VILLAGE OF DOWNERS GROVE
REPORT FOR THE VILLAGE COUNCIL MEETING
APRIL 5, 2011 AGENDA

SUBJECT:	TYPE:	SUBMITTED BY:
Special Use with Variations for 6241 Main Street	Resolution ✓ Ordinance Motion Discussion Only	Tom Dabareiner, AICP Community Development Director

**VILLAGE OF DOWNERS GROVE
REPORT FOR THE PLAN COMMISSION
FEBRUARY 28, 2011 AGENDA**

SUBJECT:	TYPE:	SUBMITTED BY:
PC-08-11 6241 Main Street	Lot Reconfiguration and Special Use with Variations for a Bank with drive-through use	Damir Latinovic, AICP Planner

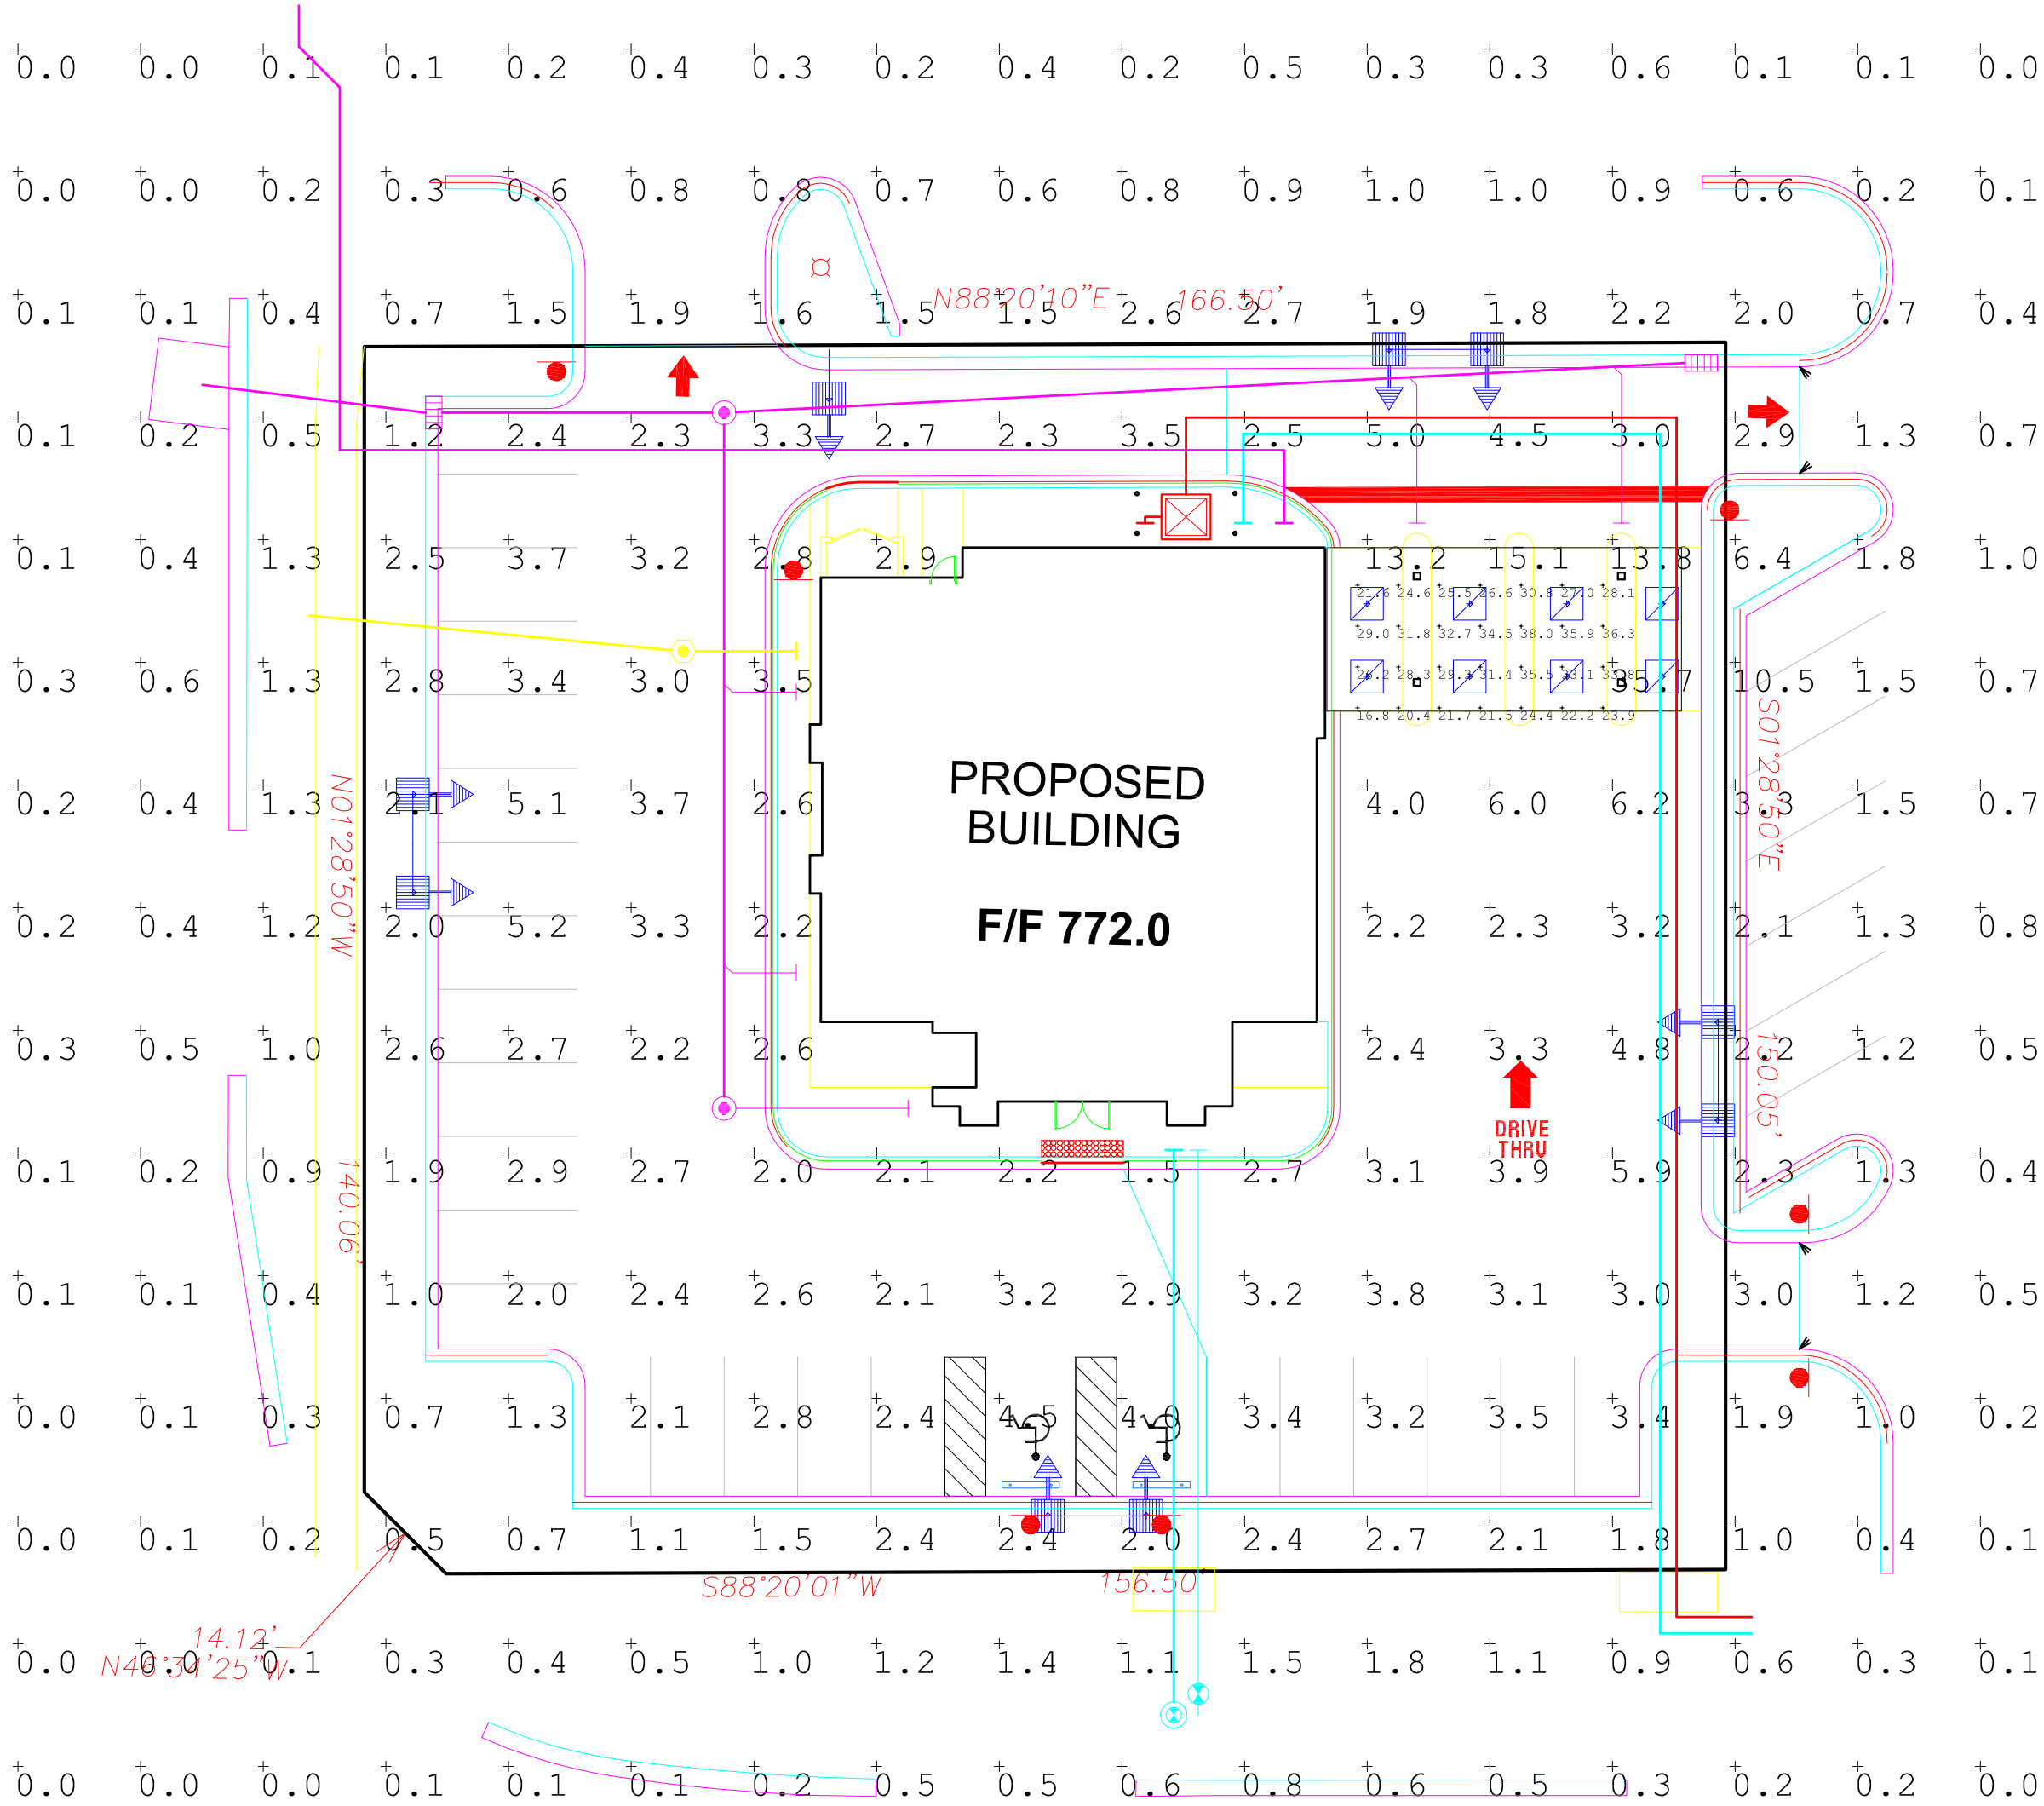
The petitioner is proposing new parking lot lighting. The proposed 30-foot high light poles meet the permitted maximum of 30 feet. Per Zoning Ordinance, the maximum foot candle readings at all property lines cannot exceed 2.0 foot candles. Also, per Zoning Ordinance, the average foot candle reading on the site cannot exceed 3.6 foot-candles. The preliminary photometric plan submitted does not meet these two lighting requirements. The petitioner has, however, indicated that the lighting plan will be revised to meet all Village requirements prior to issuance of any building permits.

2. The proposed photometric plan shall be revised to indicate that foot candle readings at all lot lines will not exceed 2.0 foot candles to meet the zoning requirements.

3. The proposed photometric plan shall be revised to indicate that the average foot candle reading on the site does not exceed 3.6 foot candles to meet the zoning requirements.

2. The proposed photometric plan shall be revised to indicate that foot candle readings at all lot lines will not exceed 2.0 foot candles to meet the zoning requirements.

3. The proposed photometric plan shall be revised to indicate that the average foot candle reading on the site does not exceed 3.6 foot candles to meet the zoning requirements.
